<b>Title - Sujet</b> Potable Water System Upgrade	
<b>Solicitation No. - N° de l'invitation</b> EZ899-133386/A	<b>Amendment No. - N° modif.</b> 002
<b>Client Reference No. - N° de référence du client</b>	<b>Date</b> 2013-03-27
<b>GETS Reference No. - N° de référence de SEAG</b> PW-\$PWY-005-6947	
<b>File No. - N° de dossier</b> PWY-2-35368 (005)	<b>CCC No./N° CCC - FMS No./N° VME</b>
<b>Solicitation Closes - L'invitation prend fin</b> <b>at - à 02:00 PM</b> <b>on - le 2013-04-04</b>	<b>Time Zone</b> <b>Fuseau horaire</b> Pacific Daylight Saving Time PDT
<b>F.O.B. - F.A.B.</b> <b>Plant-Usine:</b> <input type="checkbox"/> <b>Destination:</b> <input checked="" type="checkbox"/> <b>Other-Autre:</b> <input type="checkbox"/>	
<b>Address Enquiries to: - Adresser toutes questions à:</b> Pillay, Sal (PWY)	<b>Buyer Id - Id de l'acheteur</b> pwy005
<b>Telephone No. - N° de téléphone</b> (604) 775-9386 ( )	<b>FAX No. - N° de FAX</b> (604) 775-6633

## Addendum # 1

### **William Head Institution – Potable Water System Upgrade**

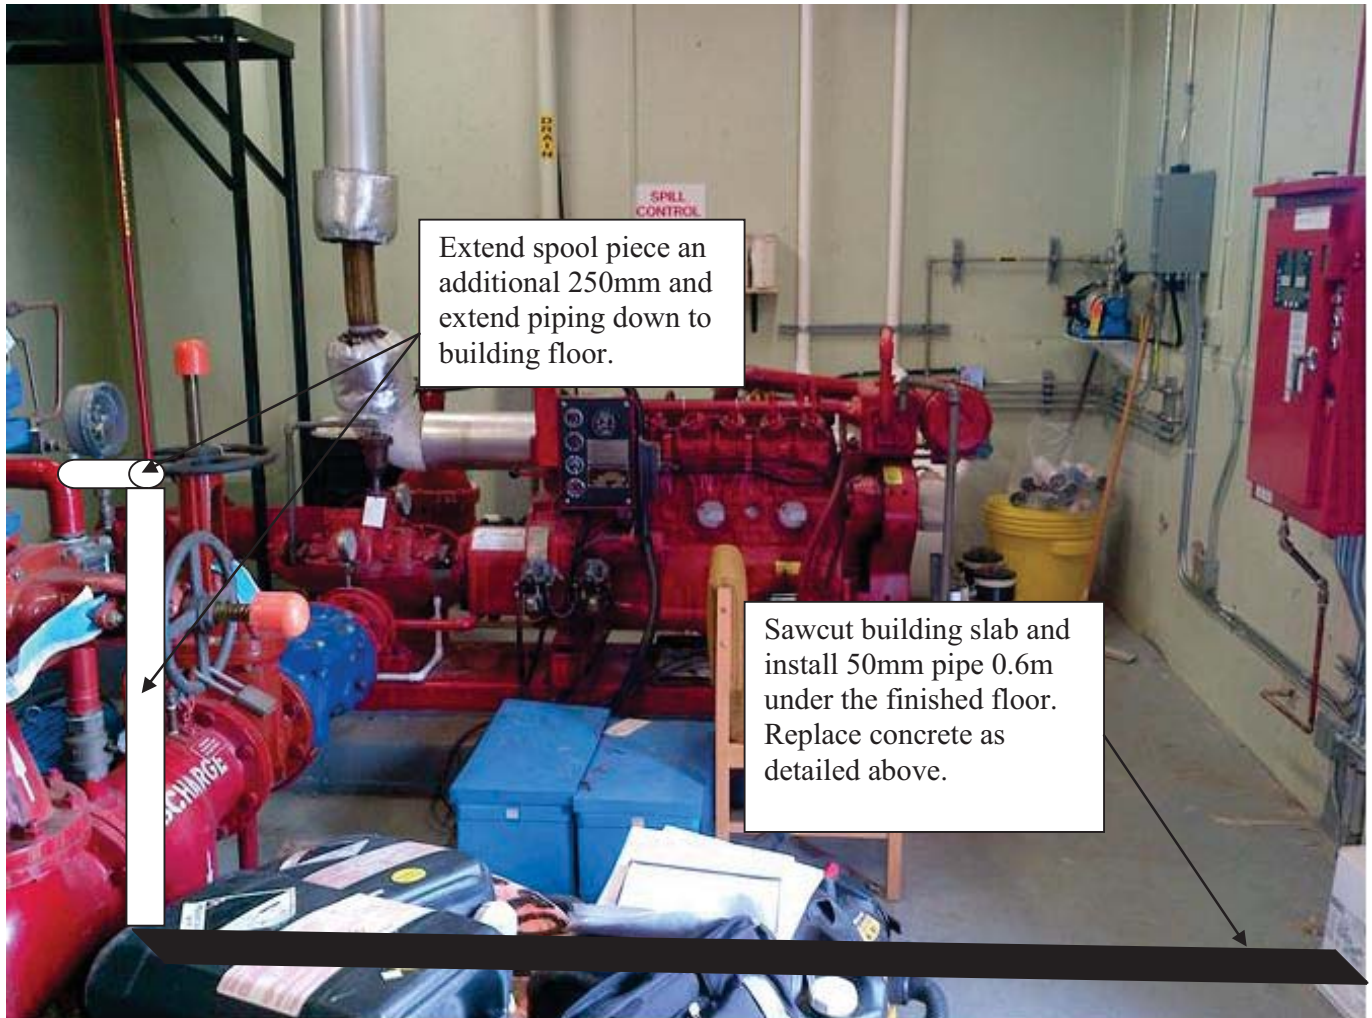
Extend spool piece an additional 250mm and extend piping down to building floor.

Extend spool piece an additional 250mm connect to new piping extending to floor.

Remove valve and cap pipe from 250mm diameter fire line

- 1.1. Delete Construction Note 11. The pre-tender meeting is not mandatory.
- 1.2. Replace Construction Note 11 with the following:
  - 1.2.1. *“Flow from the booster pump and recirc pump to be disconnected from its current tie-in to the new PRV chamber. Exact alignment of 50mm diameter watermain from Building 110 to New PRV chamber to be confirmed on-site with Departmental Representative. Plumbing work required in Building 110 is as detailed below and indicated on the attached photographs. All piping within building is to be new 50mm diameter PVC Schedule 80:*

- *Remove the valve that connects to the 250mm diameter cast iron discharge piping and cap the pipe from the discharge line.*
    - *Extend the spool piece of 50mm pipes that come from the jockey pump and recirc pump discharges an additional 250mm diameter further towards the entrance door of the building prior to connecting to the shared 50mm diameter pipe which extends down to the floor.*

- *Extend the 50mm PVC piping down to the building floor south of the 250mm diameter discharge line. Sawcut and remove the existing building floor (0.6m wide trench) and install new 50mm diameter PVC line at 0.5m depth below finished floor elevation. Align pipe to exit building through doorway to avoid walls.*

- *Replace concrete slab to existing thickness (150mm). Embed and epoxy 15M rebar 150mm minimum into the existing slab 600mm o.c. at mid depth.*
    - *Include 15M rebar running parallel to slab sawcut line at 600mm o.c. Include minimum of 2 per trench*

- *Core through the foundation wall for the pipe protrusion.*
    - *Install Robar Coupling 1.0m outside building to connect to 50mm diameter PVC pipe outside the building to the new PRV building.*
